The application of 4M change

Supplier: Zhe Jiang Rectron Electronic Co., Ltd

Date: 2018-10-26

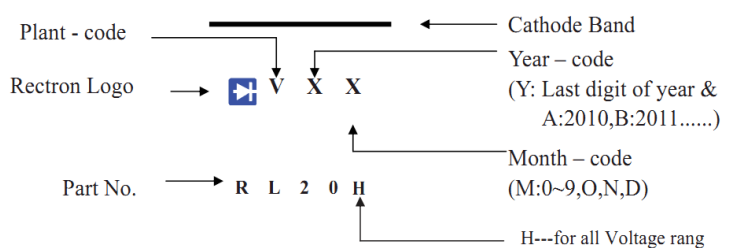
- 1) Device body marking change from "RL201", "RL202"...etc to "RL20H".
- 2) Maximum Recurrent Peak Reverse Voltage (Vrrm) rating upgraded as below.
RL201 from 50V to 1000V RL204 from 400V to 1000V RL206 from 800V to 1000V
RL202 from 100V to 1000V RL205 from 600V to 1000V RL207 no change
RL203 from 200V to 1000V
- 3) No other fit, form or function changes
- 4) If the customer disagrees with the change, We will use Z to distinguish the material number.
- 5) P/O: P/N-packing code-Z; Type: P/N-packing code; Remark : -Z (For example: P/O: RL207-F-Z; Type: RL207-F)
